An  
Bord  
Pleanála

### ABP-306146-19 & ABP-306199-19

# **Foynes to Limerick Road (including the Adare Bypass)**

## **Assessment of significant effects on the environment in respect of Soils and Geology.**

Plate 9.5: Groundwater Conceptual Site Model of Askeaton Fen SAC and its interaction with the proposed road development

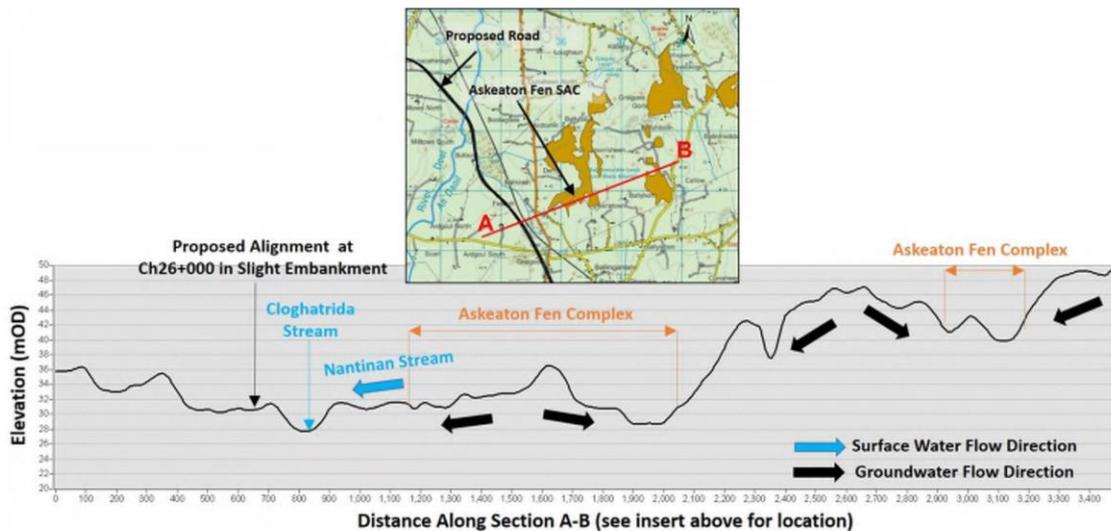
- 1.6.16. The impact assessment correctly identified potential localised changes to groundwater and surface water flow regime and hydrochemistry as small adverse magnitude localised impacts representing an imperceptible impact on the SAC. This is indicated graphically in Plate 9.5 of the EIAR which is reproduced below.

1.6.17. No potential Impact on the Askeaton Fen SAC is predicted by the applicant to arise during either the construction or operational phase and a rating of **imperceptible impact** on the Askeaton Fen Complex SAC as a result of the PRD, is deemed appropriate.
